KEMPER COUNTY IGCC PROJECT

FINAL ENVIRONMENTAL IMPACT STATEMENT

DOE/EIS-0409

VOLUME 3—RESPONSES TO COMMENTS

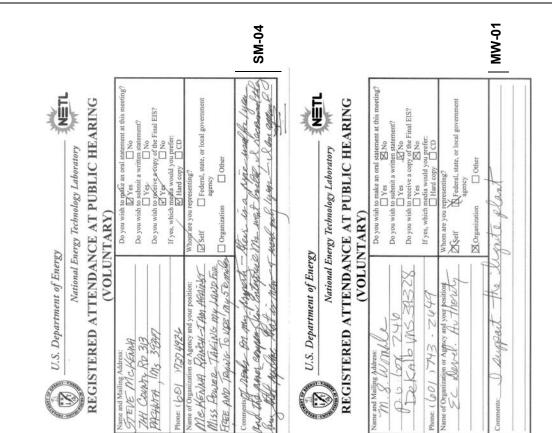
I have expressed my opposition to the proposed location of the MPC's Transmission Line across my property from the moment that I learned that was the company's plan. It is obvious that the proposed route was determined by laying a straight-edge on a map and drawing a line intom point A to point B. No consideration was given to what may be near the proposed line (like houses). The company's attitude is "what's yours must be our the proposed the way! We are taking what we want"? Never mine that I bough the property, fenced the property, cleared the property, pay taxes on the property and MIC has done none of those things.

My little place is only twenty acres of open land. Highway 495 is my boundary on the entire East side. Brown Hooke Road is the boundary on the entire North side. EMEPA already has Power Line own my property down both of these roads. MPC proposes to locate their Transmission Line over EMEPA's line on the Northeast of my property and run it diagonally across to the Southwest of my property. This would place the line very close to my house on Brown Hooke Road and just behind my neighbor's house on Highway 495. Another neighbor has a house across the road from me. Locating the line so close to these three houses would not only be an "eye-sore", but would destroy our property value! No one would want our now valuable property any more and we would be forced to stay next to the unsightly monstrosity.

I suggested that the Transmission Line be located across Highway 495 along the Tennessee Gas Line that thas been there for more than fifty years. The gas line runs through to south Meridian and houses and development are not located real close to it. My question is: If houses cannot be built close to existing Transmissions Lines and Pipe Lines, why can new Transmissions Lines and Pipe Lines be Located close to existing houses? Why can't good common sense be used? Apparently, no serious consideration has been given to rerouting the line away from our houses because 1 have not had a communication with MPC since September 25, 2008 (over a year) and two of my neighbors were contacted by MPC has veck to negotiate a payment amount for putting the line on their land. If seems to me that MPC is putting the horse before the wagon by assuming that they already have your (Public Service Commission) approval.

| RW-01: | Infrastructure in relation to county responsibility and associated cost |
|-----------|--|
| Response: | Comment noted. |
